Service Bulletin

Floor Rib 10 and 11 Reinforcement

Figure 1: GA8 and GA8-TC 320 Floor Rib Locations (View looking down on Floor)

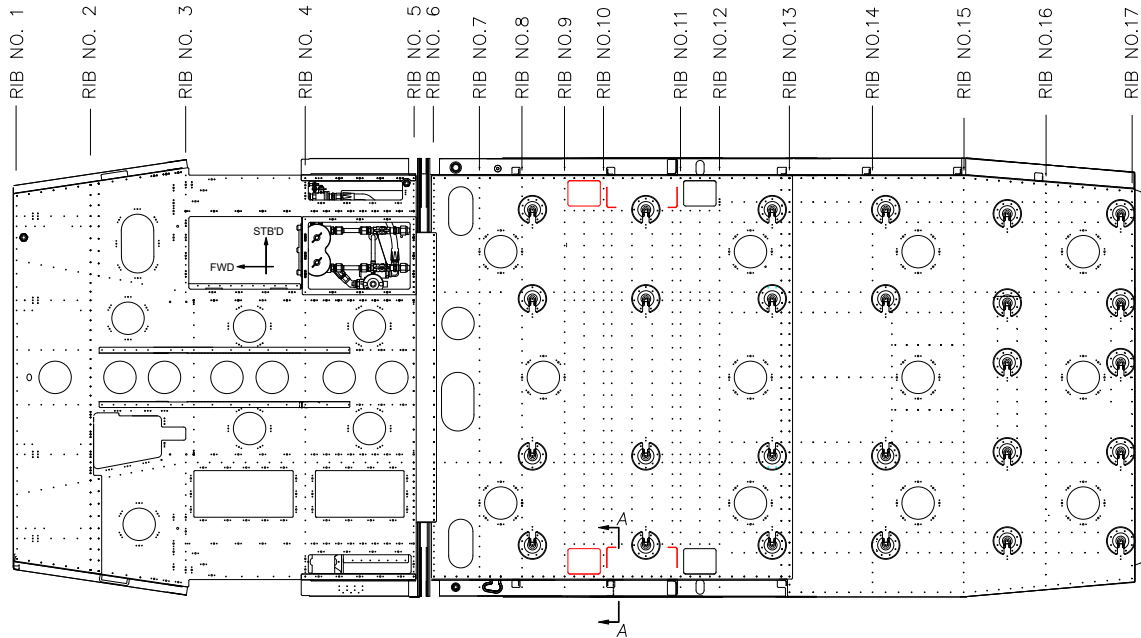
Floor ribs of the GA8 and GA8-TC 320 are numbered as shown in Figure 1. The affected rib locations, and the hatches which must be installed to access Rib #10 are marked in red.

- **Part A** of this Service Bulletin installs access panels to the floor and doublers to Rib #10 on the port and / or starboard side of the aircraft.
- **Part B** of this Service Bulletin installs doublers to Rib #11 on the port and / or starboard side of the aircraft.

Figure 2: Section A-A: Typical Crack Location and Doubler Installation

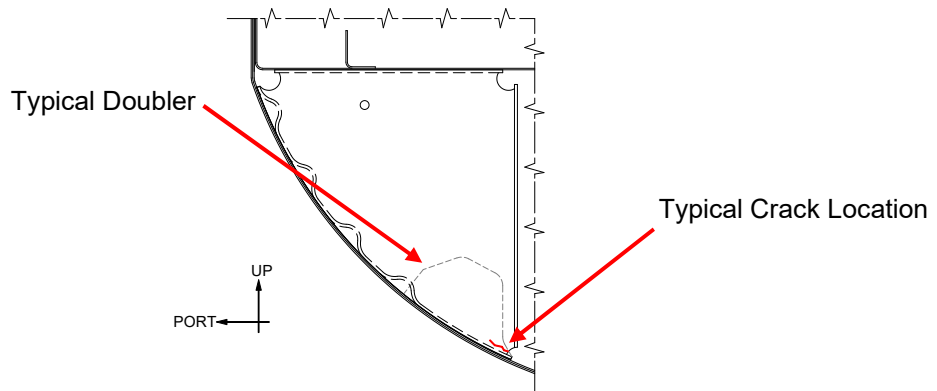
This Service Bulletin provides instructions to install reinforcement doublers to the outboard floor ribs number 10 and 11. The doublers may be installed as a preventative measure for aircraft operating from unprepared runways or may be used to repair cracks in the affected ribs.

Figure 3: Maximum Crack Size

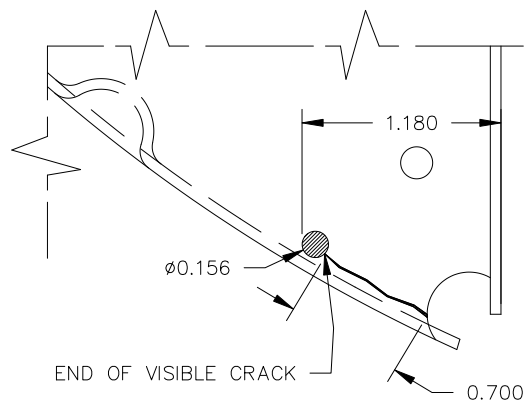
Where this Service Bulletin is being used to address cracks in Rib #10 and #11, the cracks must be less than 0.700" in length and, including a $\varnothing 0.156$ " stop-drill, be less than 1.180" when measured from the rib flange, as shown in Figure 3.
